PRODUCT/PROCESS CHANGE NOTICE (PCN)

PCN #: A1911-01		DATE: 26-Nov-2019	MEANS OF DISTINGUISHING CHANGED DEVICES: ☒ Product Mark 2D barcode on product marking ☐ Back Mark ☐ Date Code ☐ Other
Product Affected: FCBGA53 and FCBGA253 (Refer to attachment II for affected part#)			
Date Effective: 26-Dec-2019			
Contact: IDT PCN DESK	Attachment: ☒ Yes ☐ No		
E-mail: idt-pcn@lm.renesas.com	Samples: Please contact your local sales representative for sample request.

ATTACHMENT I - PCN # : A1911-01

2D Barcode Information

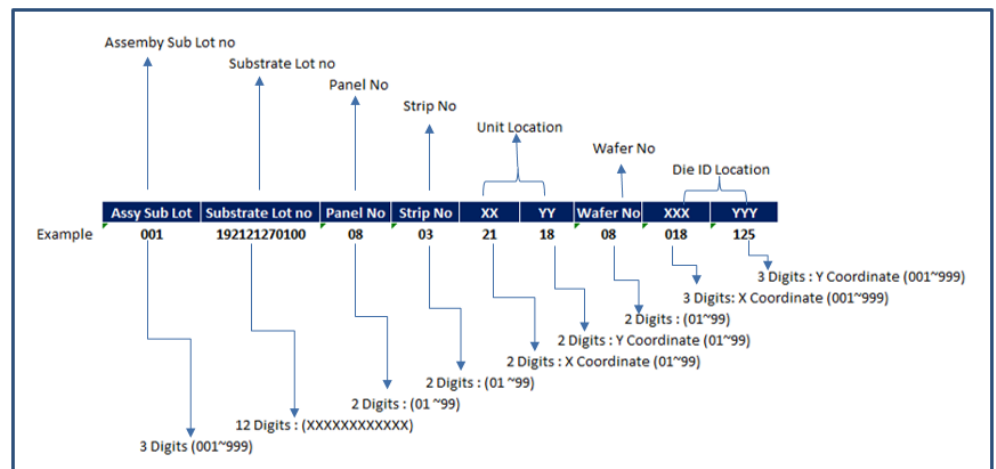
This notification is to advise our customers that IDT is adding 2D barcode on the product marking to improve traceability. The 2D barcode contains wafer and substrate information.

RCD: 13.5 x 8.0 mm

DB: 7.5 x 3.0 mm

DDR4 RCD Marking Format and Dimension

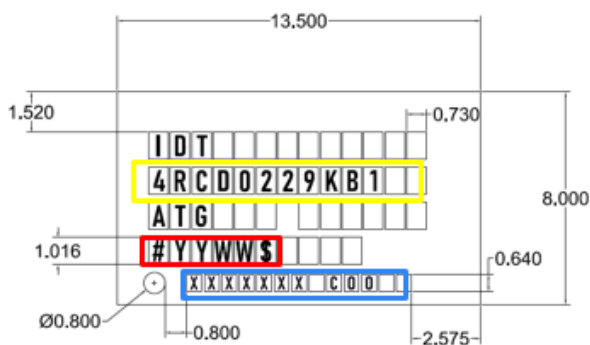
- Fixed Substrate level 2D ID Content
 - 17 digit max
 - Lot no (12) + PP + SS
- Combine Sublot + Substrate 2D ID info + Unit code + wafer and die ID and mark into IDT Unit
 - Total 31 digits
 - Assembly Sublot (3)
 - substrate Lot no (12)
 - Panel No PP(2)
 - Strip No SS(2)
 - Unit Location, XXYY(4)
 - Wafer ID WW(2)
 - Die Location XXXYYY (6)

DDR4 DB Marking Format and Dimension

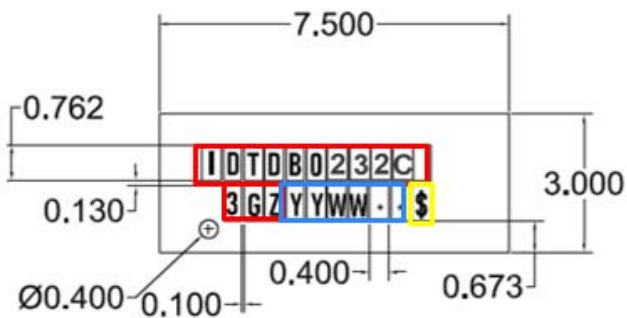
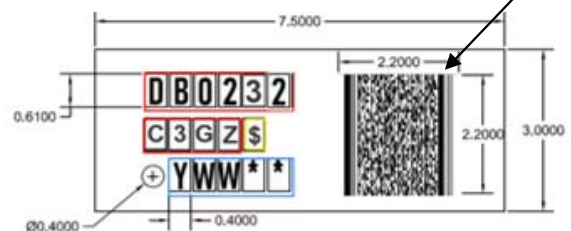
- Fixed Substrate level 2D ID Content
 - 17 digit max
 - Lot no (12) + PP + SS
- Combine Sublot + Substrate 2D ID info + Unit code + wafer and die ID and mark into IDT Unit
 - Total 31 digits
 - Assembly Sublot (3)
 - substrate Lot no (12)
 - Panel No PP(2)
 - Strip No SS(2)
 - Unit Location, XXYY(4)
 - Wafer ID WW(2)
 - Die Location XXXYYY (6)
